Thank you for giving me the opportunity to comment on UDC 2015-17, concerning a roundabout at Belmont Road and West Belmont Road.

From: [Dawn Page](#)
To: [Eastman, Jeff R. - PDR](#)
Subject: Roundabout at the intersection of Belmont and West Belmont Rds
Date: Wednesday, July 08, 2015 10:08:31 PM

Figure 3-9: Refined Network Recommendations

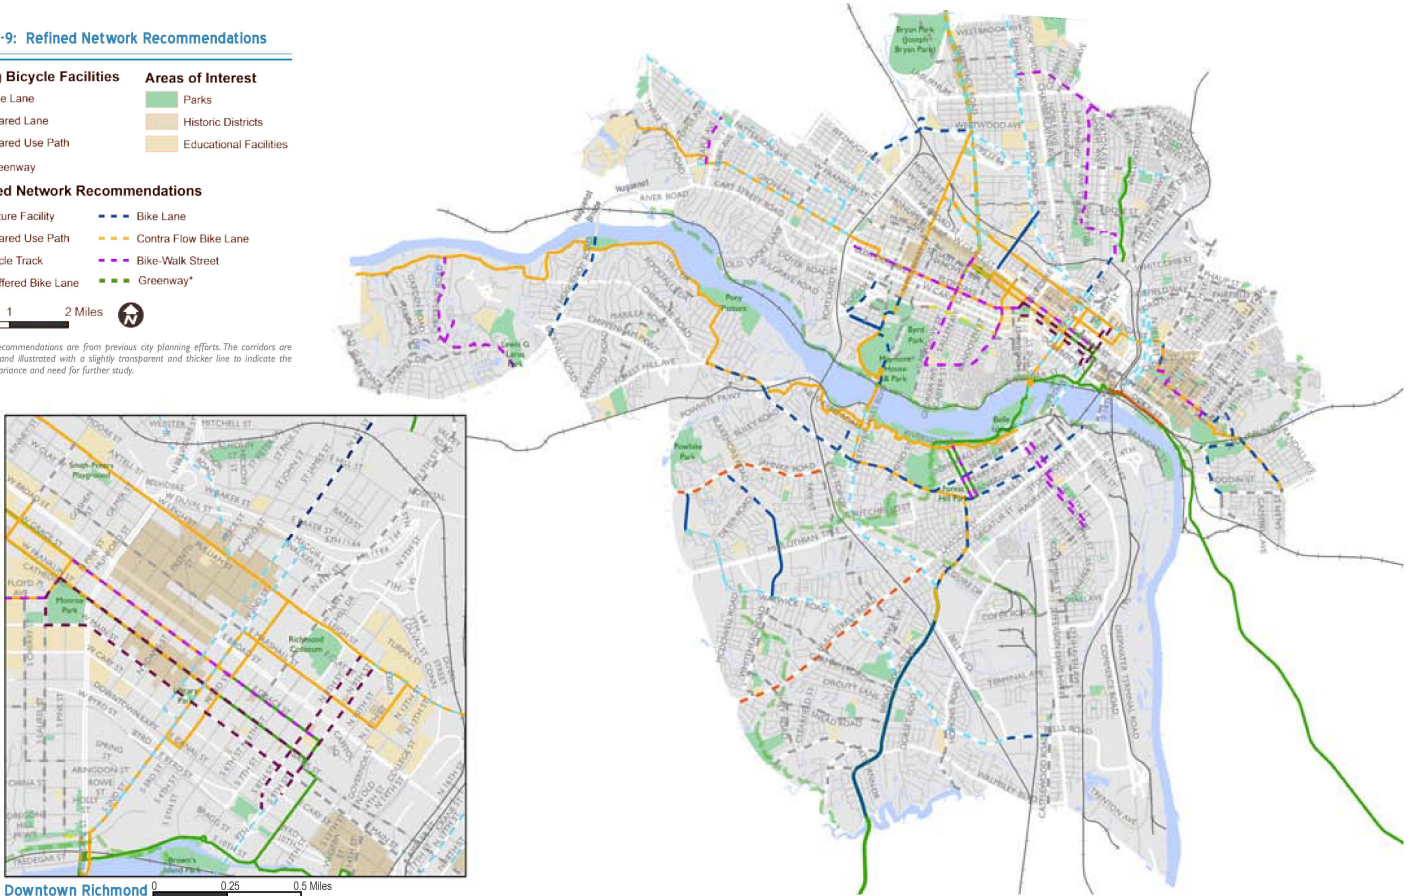
The recently produced Bicycle Master Plan has laid out corridors for future bicycle infrastructure over the next decade and beyond. The current and proposed network can be seen in Figure 3-9 (page 3-9, or page 45 of the pdf, see attachment). The current network features a bike lane on Iron Bridge Road, part of Bicycle Route 1, which stretches from Maine to Florida; this lane intersects with West Belmont Road only 1,500 feet from the proposed roundabout. The proposed bicycle network includes a bicycle facility along West Belmont Road from Iron Bridge Road to this intersection, and along Belmont Road in both directions of this intersection. Given that three legs of this proposed roundabout are roads with proposed bicycle infrastructure, the city should be planning now to accommodate cyclists at this intersection, rather than having to pay for this again later; the cost and trouble of planning for cyclists with this project will be very little today compared to doing it a few years from now.
